Illinois Department of Transportation

SUBJECT: MidAmerica St. Louis Airport
Mascoutah, Illinois
St. Clair County
Illinois Project Number: BLV-5101
AIP Project Number: 3-17-0146-TBD
Contract No. SC071
Item No. 02A, April 26, 2024 Letting
Addendum A

NOTICE TO PROSPECTIVE BIDDERS

ADDENDUM A PLAN SHEET REVISIONS

SHEET 59B OF 68

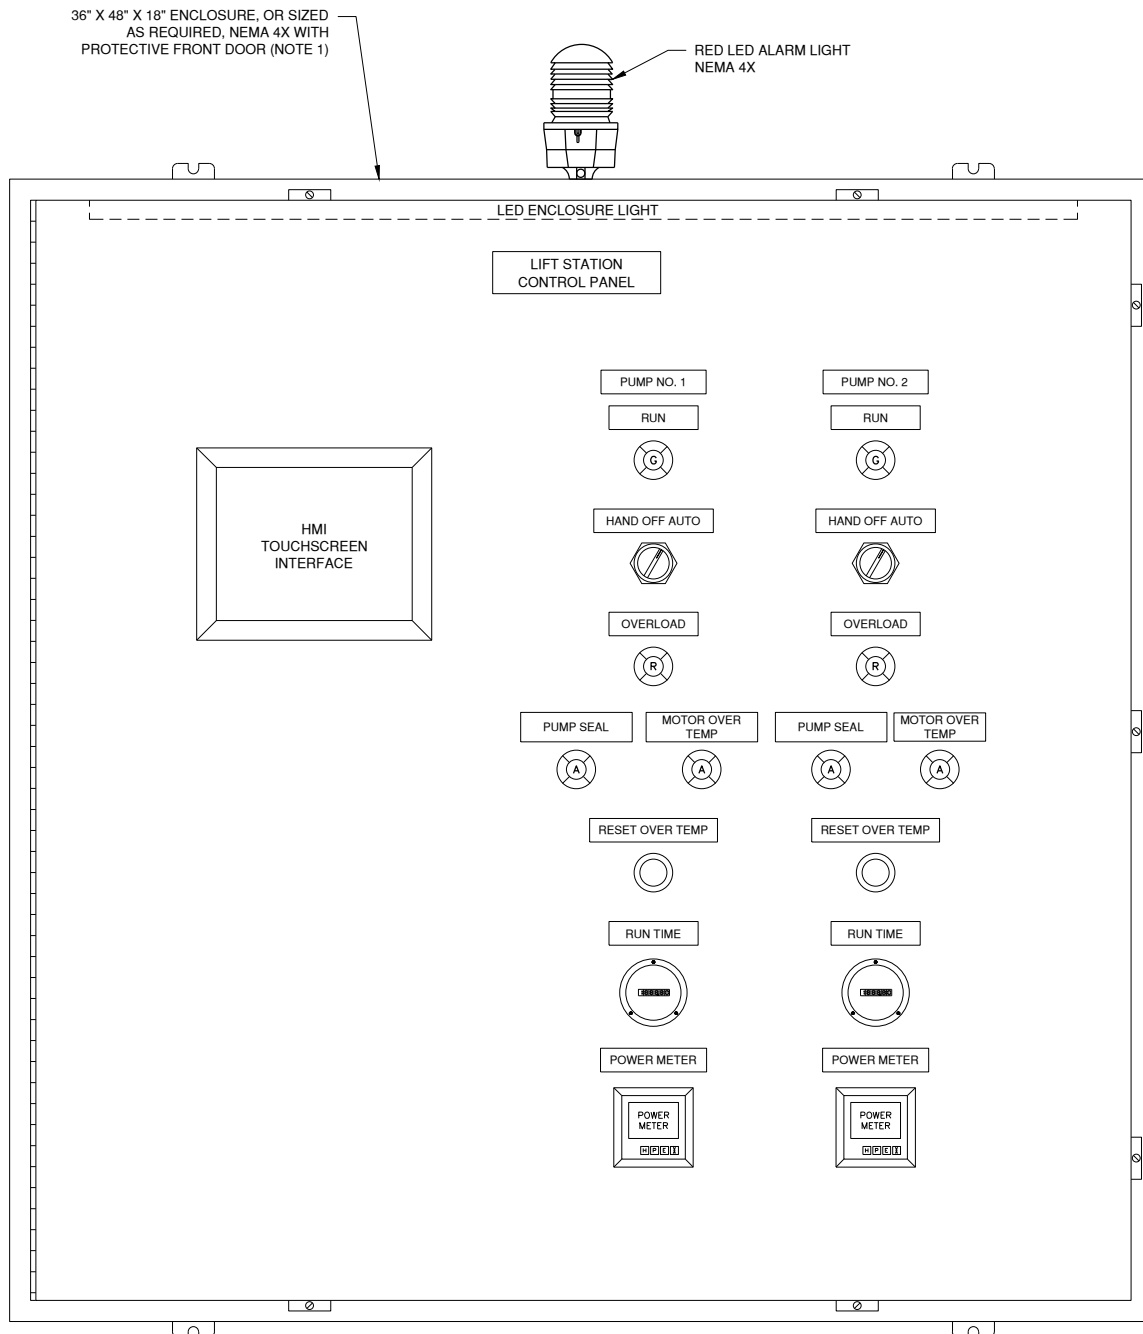
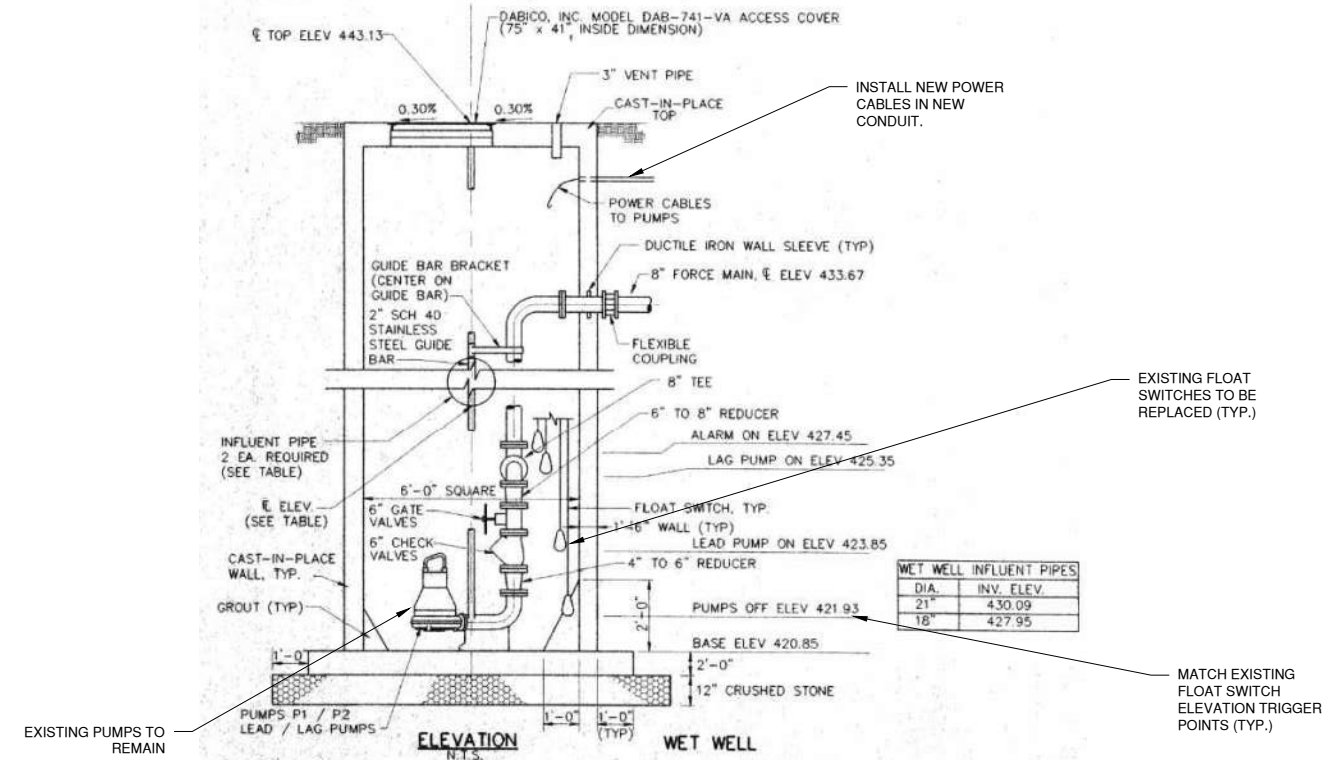
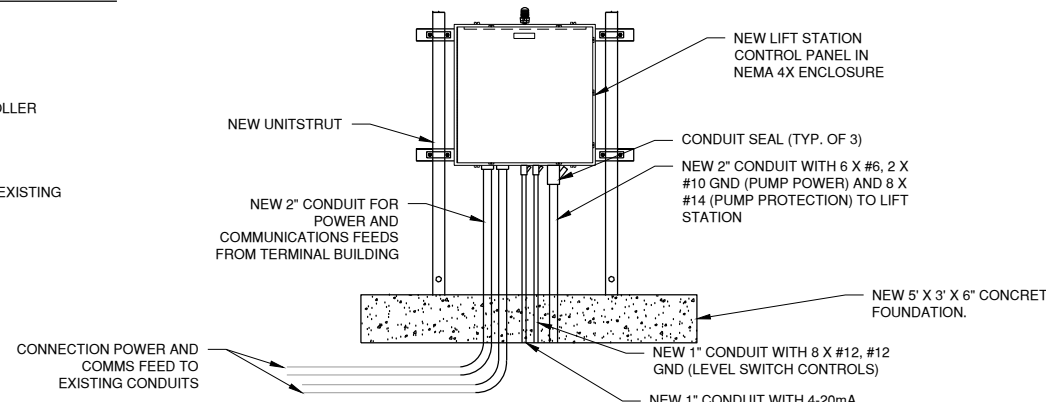
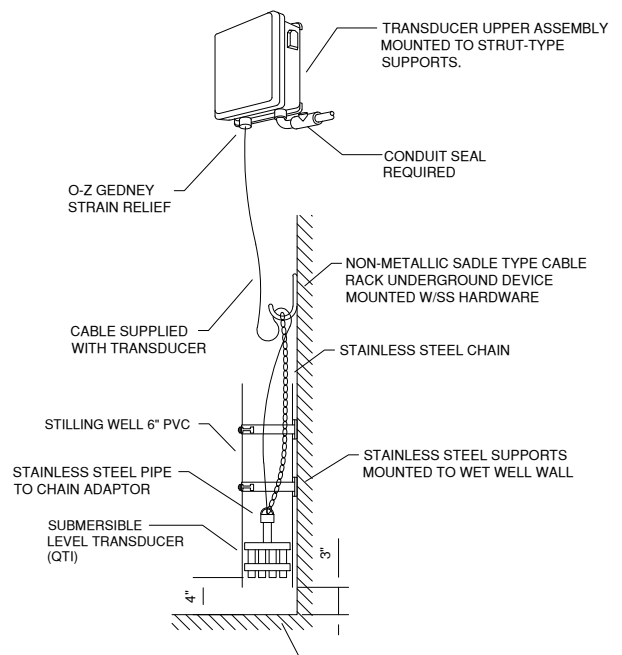
- Sheet CM501
 - Updated to add note for space numbers to Fuel Truck Parking Space Marking detail
- Sheet CM502
 - Updated to add detail for Service Road Yield Sign Support Detail
- Sheet EL101
 - Updated to cleanup linework
- Sheet EL102
 - Updated to cleanup linework and move location of light pole.
- Sheet EL501
 - Updated to add clarify Base Mounted Medium Intensity Light Detail
- Sheet EL502
 - Updated to add dimensions to Concrete Encased Duct Bank details for depth from surface
- Sheet EL507
 - Added for the addition of the Glycol Lift Station Control Panel
- Sheet EL508
 - Added for the addition of the Glycol Lift Station Control Panel
